Remarks

The Office Action dated February 21, 2006, indicated that the drawings are objected to; the claims are objected to; claims 1-10 stand rejected under 35 U.S.C. §112(2) for alleged nonconformance to current U.S. practice; claims 1, 3, 5 and 9 stand rejected under 35 U.S.C. §103(a) over Pan *et al.* (U.S. Pat. 5,834,358) in view of Ajuria *et al.* (U.S. Pat. 5,837,612); claims 2, 6 and 8 stand rejected under 35 U.S.C. §103(a) over Pan in view of Ajuria and further in view of Peterson *et al.* (U.S. Pat. 6,545,299); claims 4 and 10 stand rejected under 35 U.S.C. §103(a) over Pan in view of Ajuria and further in view of Lam (U.S. Pat. 6,413,828); and claim 7 stands rejected under 35 U.S.C. §103(a) over Pan in view of Ajuria and Peterson, and further in view of Lam.

FIG. 3

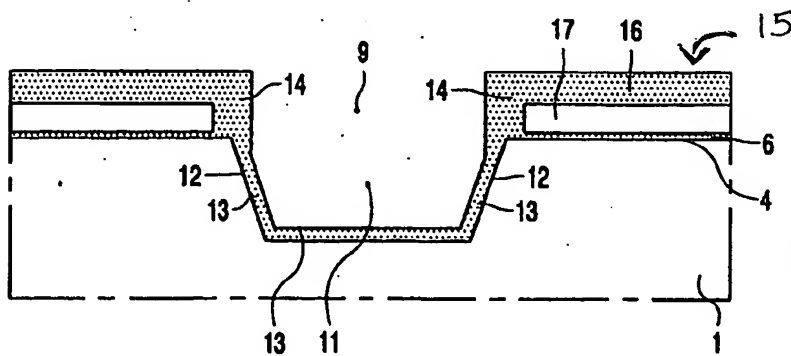
With respect to the objection to the drawings, Applicant has amended FIG. 3 to reflect an upper side 15 in a manner commensurate with the Examiner's request and the discussion in the Specification. Applicant requests that the objection to the drawings be removed.

FIG. 3: Reference no. '15' added as identified at page 4, line 33
 of the specification.
